Comment (#57, #58):
(TDL #513 D2.0).

The following updates to the unbalance requirements are based on the technical principles, 4-pair model and its component values presented Annex D that was used to derive all pair-to-pair unbalance requirements in 802.3bt.

Results:

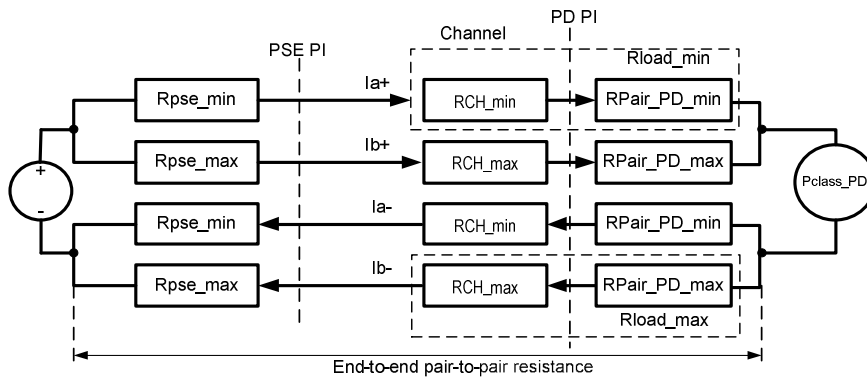
- In simulation, we get accurate results for I_{con-2P_unb} that meets the spec.
- When using single calculation iteration of I_{con-2P_unb} : I_{con-2P_unb} is deviates by +9mA (error=1.31%).
- When using two calculation iterations by subtracting R_{load_min} and R_{load_max} power loss from Ppd, error is reduced and we meet the spec.
- When using two calculation iterations by when breaking R_{load} to R_{ch} and R_{pair_PD} and subtracting R_{pair_PD} loss from Ppd, error is reduced and we meet the spec which prove the point above that for short cable there is need to break the model from 2 parts to 3 parts.
 - The reason for why without breaking R_{load} to R_{ch} and R_{pair_PD} we get the same good results is that at short cable R_{ch} is negligible compare to R_{pair_PD} which is part of the PD.

1. There is no need to calculated $I_{con_2P_unb}$ to meet the spec. The designer need to meet Equation 33-15 only.
2. Equation 33-15 is correct and accurate. No changes are needed.
3. In order to validate that the PSE vendor meets Equation 33-15, he should use Annex 33-B test models as indicated in the spec.
4. For the above use case in short cable, no need to change the model as currently specify in Annex B however it is recommended to do so due to the following:
 - a) It is clearer model that include all necessary information for the designer.
 - b) For long cables, we must break R_{load} to its R_{ch} and R_{pair_PD} components since in this case $R_{ch}>R_{pair_PD}$ which will result with significant error.

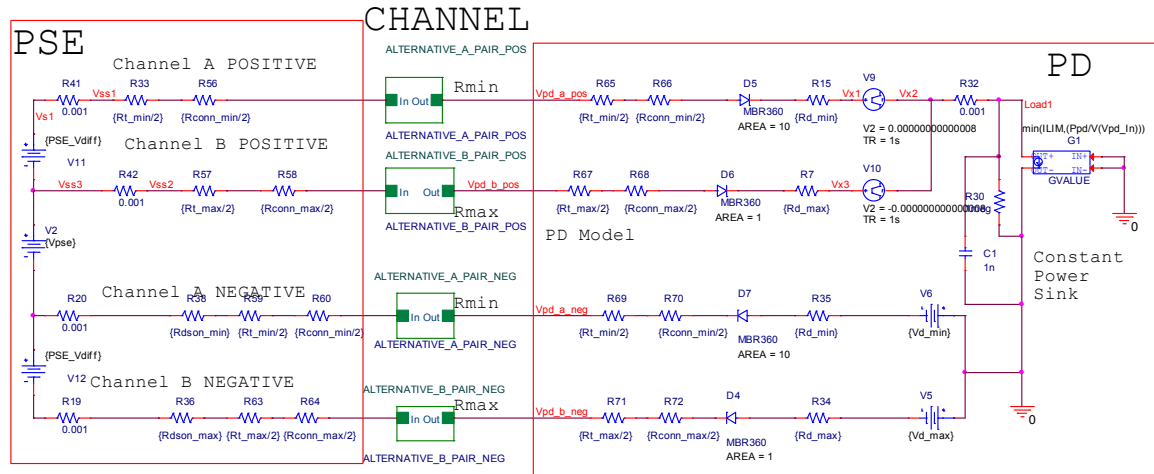
The E2EP2PRunb that was used to derive the U value in Equations 33D-2 and 33D-3 above is found at short cable in order to find the worst case unbalance due to the fact that with long cables the unbalance is improved. Maximum pair current due to E2EP2PRunb is not always obtained at the maximum value of E2EP2PRunb. For Type 3 systems, maximum pair current is obtained at R_{chan-2P}=0.2Ω (short cable) where E2EP2PRunb is the highest. For Type 4 systems, maximum pair current is obtained at R_{chan-2P}=12.5Ω (at 100m channel length) where E2EP2PRunb is the lowest.

1. Replace Figure 33B-1 with the following:
